**Field Sampling Plan for Baseline Groundwater and  
Surface Water Characterization at the Proposed  
Environmental Management Disposal Facility,  
Oak Ridge, Tennessee**

DOE/OR/01-2812&D2

<b>Document Number:</b> DOE/OR/01-2812&D1	<b>Document Title:</b> <i>Field Sampling Plan for Baseline Groundwater and Surface Water Characterization at the Proposed Environmental Management Disposal Facility, Oak Ridge, Tennessee</i>	
<b>Name of Reviewer:</b> Randy Young	<b>Organization:</b> TDEC	<b>Date Comments Transmitted:</b> 10-21-2022

<b>Document Number:</b> DOE/OR/01-2812&D1	<b>Document Title:</b> <i>Field Sampling Plan for Baseline Groundwater and Surface Water Characterization at the Proposed Environmental Management Disposal Facility, Oak Ridge, Tennessee</i>	
<b>Name of Reviewer:</b> Carl Froede	<b>Organization:</b> EPA	<b>Date Comments Transmitted:</b> 12-1-2022

Fig. 3. Baseline monitoring locations.

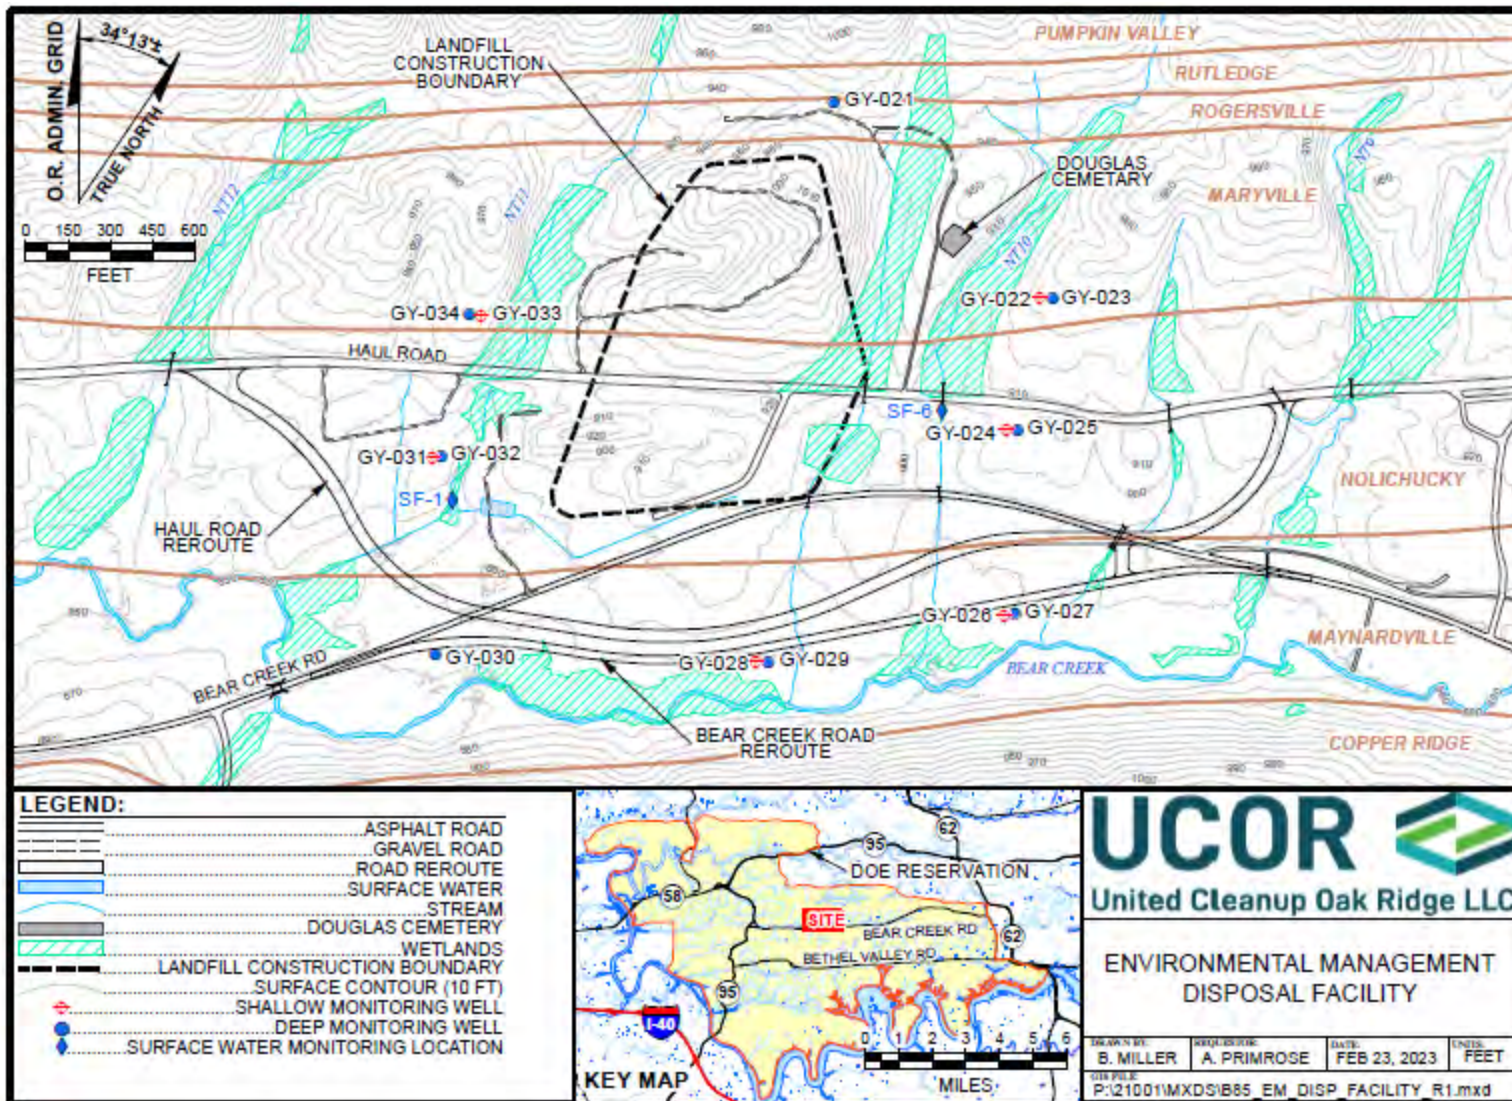
Comment No.	Sect/ Page	Comment	Response
4	Fig. 3 pg 8	<p>Baseline monitoring locations</p> <p>The figure Legend does not define the four outlined areas that are shown. Additionally, the blue colored outlined areas near NT-11, D-10W and NT-10 are not shown or defined in the Legend.</p> <p>Furthermore, the figure does not include a north arrow for reference. Please revise Figure 3 to include this information and any other information necessary to understand the figure.</p>	<p>Agree. The figure was updated, the proposed sediment basins were not necessary and were removed and a north arrow was added.</p>
5	Sect. 3.1 pg 11	<p>Monitoring Network</p> <p>The text states that the downgradient wells installed in the Maynardville Limestone will obtain baseline data from an area noted to have “periodic plume extension” from the upgradient groundwater plumes migrating along Bear Creek; however, it is unclear what contaminants these upgradient plumes contain. Also, it is unclear how the future sampling results will be assessed if the plume extensions impact baseline values. For example, it is unclear if an additional downgradient well located closer to the EMDF or an additional upgradient well along Bear Creek would be useful. Please revise this section to discuss the contaminants in the upgradient plumes and how future sample results will be evaluated if the plume expansions impact the baseline characterization results.</p>	<p>Agree. The following text was added: “Because contamination is expected to be present in the downgradient Maynardville Limestone baseline monitoring wells, these data are expected to provide baseline conditions at these locations to differentiate between potential future leakage from the EMDF and what is already present in the groundwater.”</p>

Comment No.	Sect/ Page	Comment	Response
		<p>shallow/deep well pairs along the western/southwestern landfill boundary. Therefore, TDEC recommends another shallow/deep well pair in the baseline monitoring network near the northwestern/western corner of the landfill footprint-Le., uphill from the planned location of GY-033/034.</p> <p>b. Are any of the existing site characterization piezometers-not shown on the map suitable for baseline groundwater sampling? Piezometer construction information presented in TM-2 suggests they may fit for sample collection.<sup>1</sup> Some existing piezometers appear to be outside the planned landfill footprint. If those piezometers are not used for baseline groundwater sampling, DOE should consider continuing groundwater level recording at those locations to support baseline monitoring and the groundwater field demonstration.</p> <p>c. Add a north arrow, and indicate whether it represents true north or grid north.</p> <p>d. Define the polygons in the legend.</p> <p><small><sup>1</sup> Technical Memorandum #2, Environmental Management Disposal Facility Phase 1 Monitoring, Oak Ridge, Tennessee (DOE/OR/01-2785&amp;D1) and Responses to Comments on Technical Memorandum #1, Environmental Management Disposal Facility Phase 1 Monitoring, Oak Ridge, Tennessee (DOE/OR/01-2785).</small></p>	<p>b. Clarification provided. The site characterization piezometers will not be used for baseline monitoring because these do not meet the requirements for an ORR monitoring well. Piezometers continue to be used for groundwater level recording, but will be plugged and abandoned when landfill construction activities begin.</p> <p>c. Agree.</p> <p>d. Agree. The proposed sediment basins were removed and the figure was updated to match the current design configuration.</p>
